Well Name: RIVERBEND FED	Well Location: T24S / R29E / SEC 22 / SWNW /	County or Parish/State: EDDY / NM
Well Number: 9	Type of Well: OTHER	Allottee or Tribe Name:
Lease Number: NMNM81586	Unit or CA Name:	Unit or CA Number:
US Well Number: 300152886100S2	Well Status: Producing Oil Well	Operator: OXY USA INCORPORATED

Notice of Intent

Type of Submission: Notice of Intent	Type of Action Plug and Abandonment
Date Sundry Submitted: 07/29/2021	Time Sundry Submitted: 01:49
Date proposed operation will begin: 12/28/2021

## PLUG AND ABANDONMENT CONDITIONS OF APPROVAL

Proposed Wellbore  
**Riverbend Fed #009**  
30-015-28861-0000  
Eddy

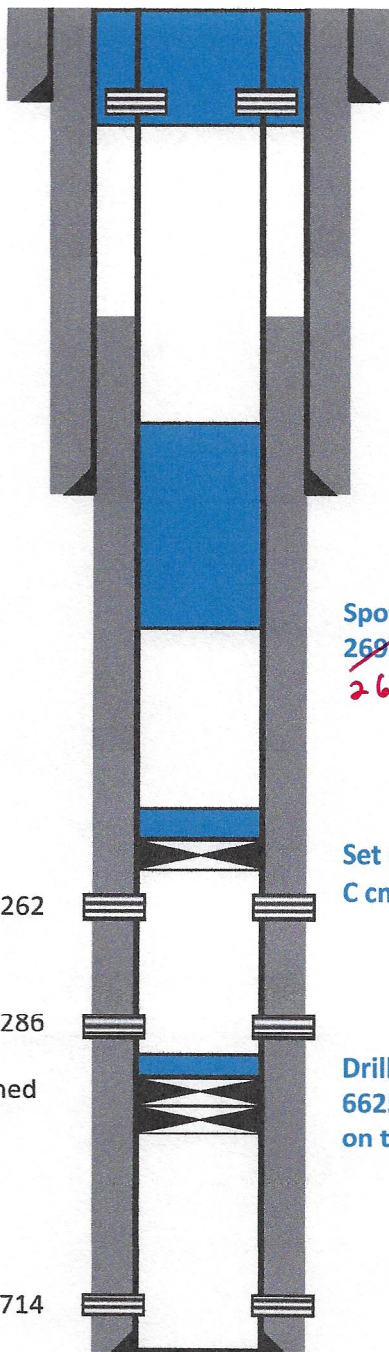
3. Spot 105' sx Class C cmt 3892'-<sup>2660'</sup>~~2695'~~ *WOC & TAG*

4. Perf and squeeze 135 sx Class C cmt <sup>582'</sup>~~582'~~-surface *(In/out) Verify @ surface*

Perf and squeeze 135 sx Class C  
cmt ~~582~~-surface.

Spot 105 sx Class C cmt 3892-  
~~2695~~.

2660'
